REMARKS

I. Objection to Drawings

FIG. 8
PAGER

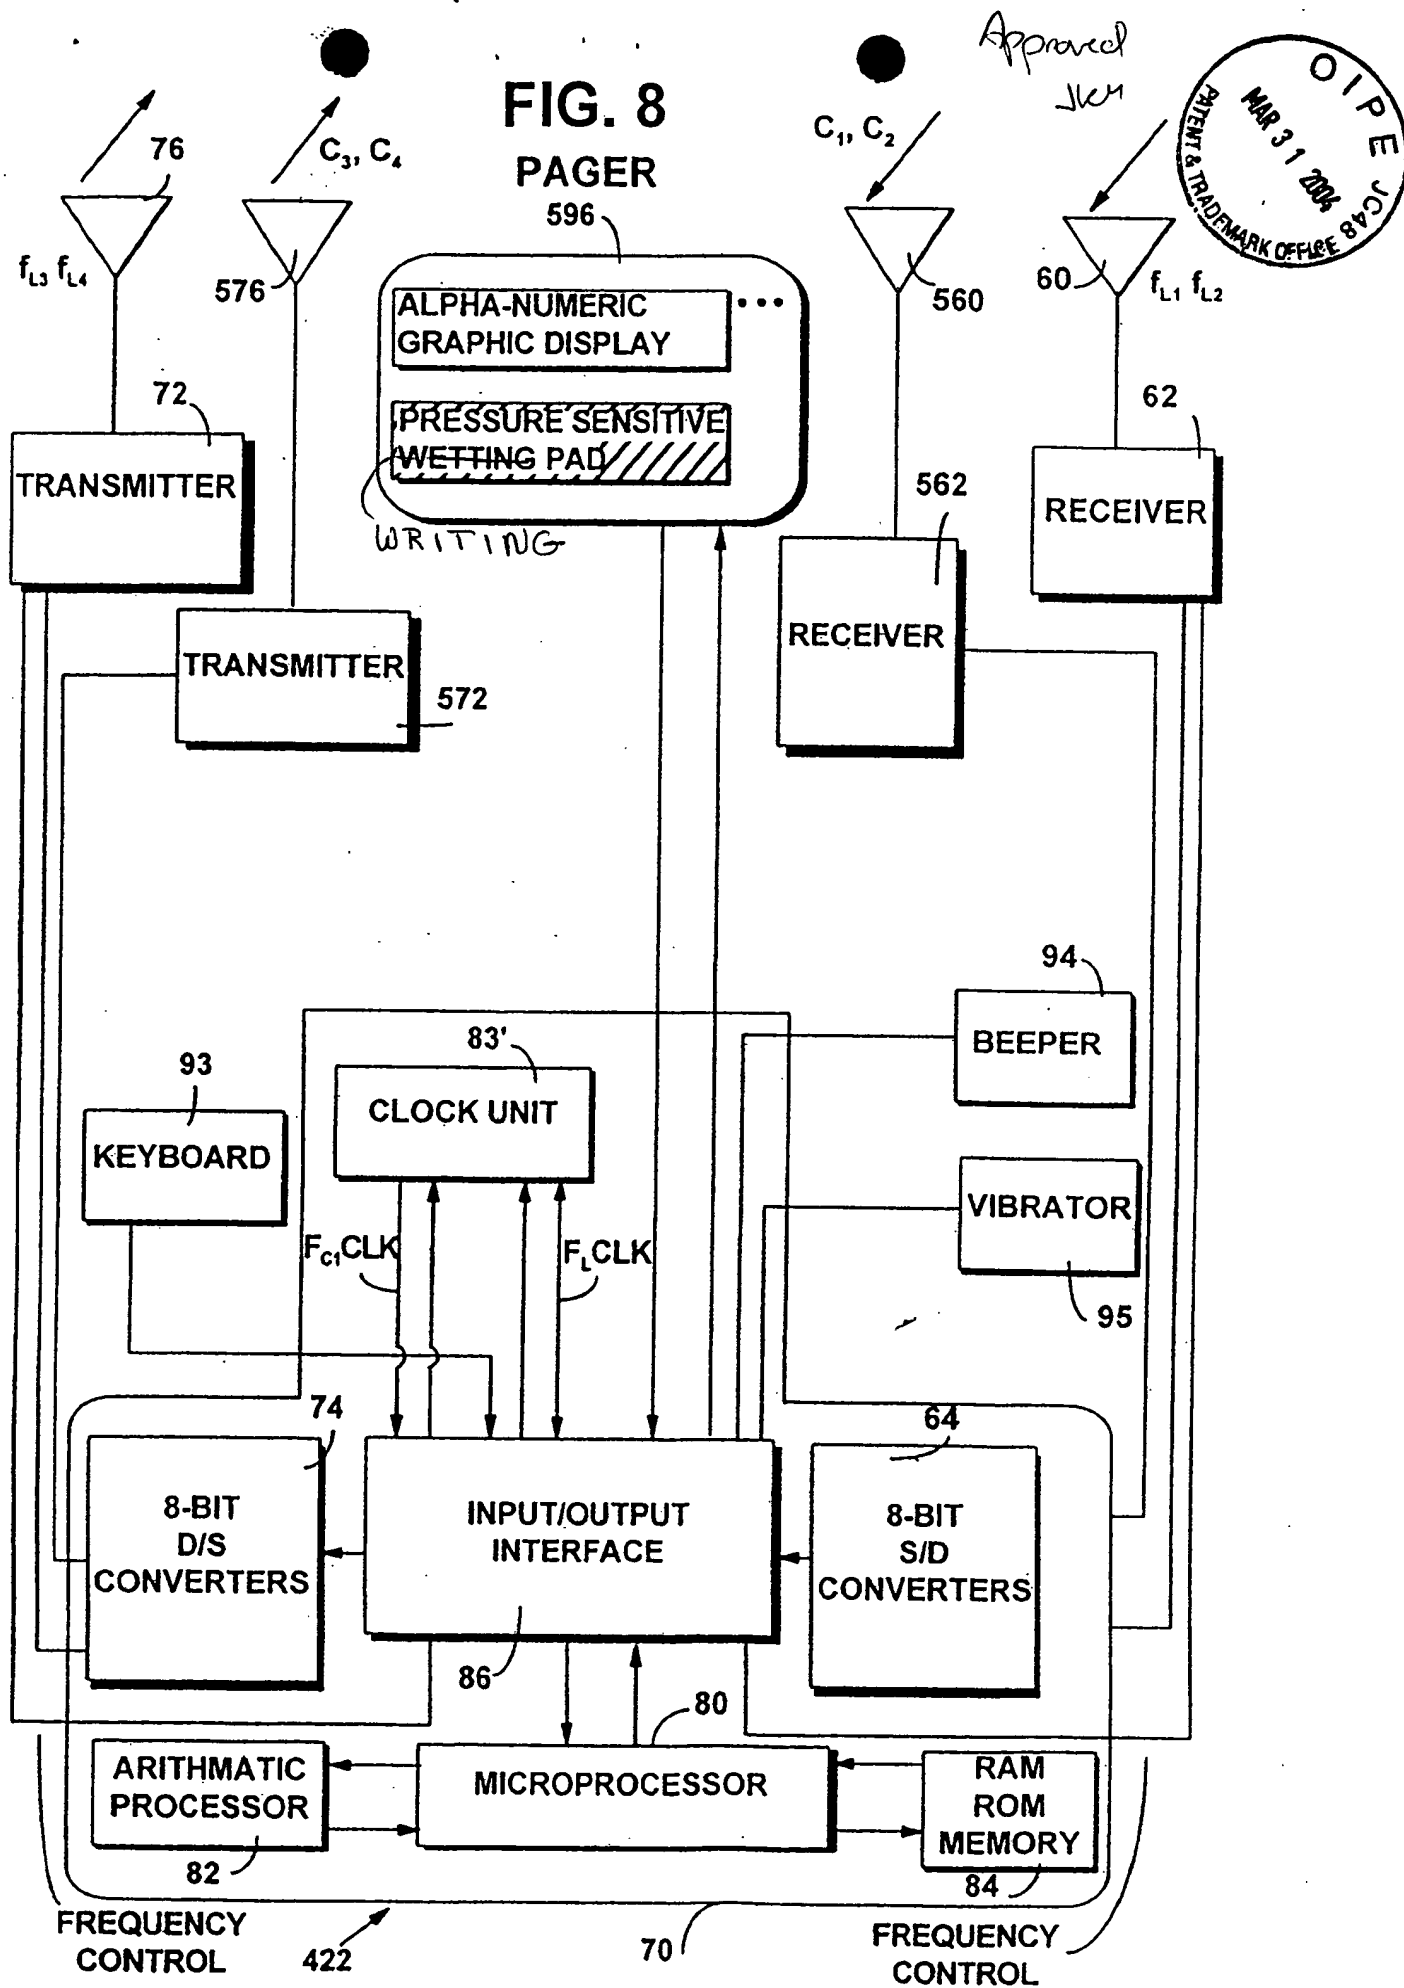
In Fig. 8, box 596, "WETTING" should be changed to "WRITING".

In response, Applicants have amended the drawings as requested. Accordingly, Applicants request that the drawing objections be withdrawn.
